Subject: FRONT BUMPER REINFORCEMENT RIB - SERVICE TIP	Bulletin No: 09-004/06
	Last Issued: 1/31/2006

2006 Mazda5

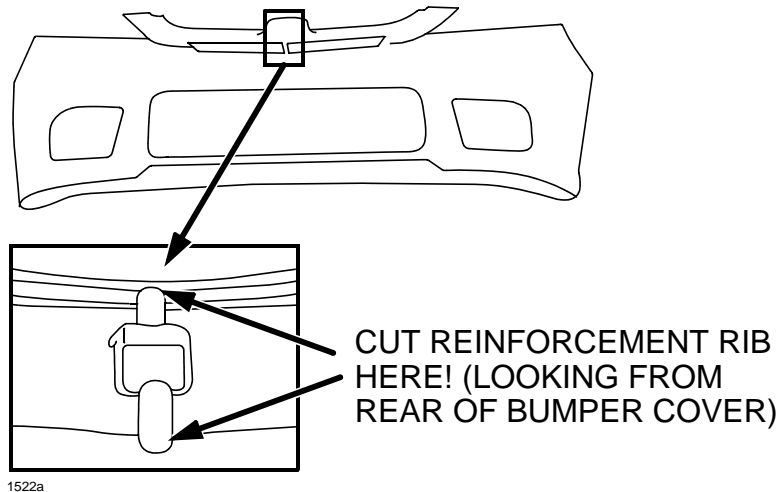
On replacement front bumper covers for 2006 Mazda5 vehicle, a reinforcement rib is manufactured into the bumper cover at the radiator grille opening. The purpose of this reinforcement rib is to prevent deformation during storage and transportation.

When preparing and installing a new front bumper cover (CC53-50-031C AA) to a vehicle, paint the bumper cover first, then remove the reinforcement rib. If the reinforcement rib is not removed from the bumper cover, the radiator grille will not be able to be installed.
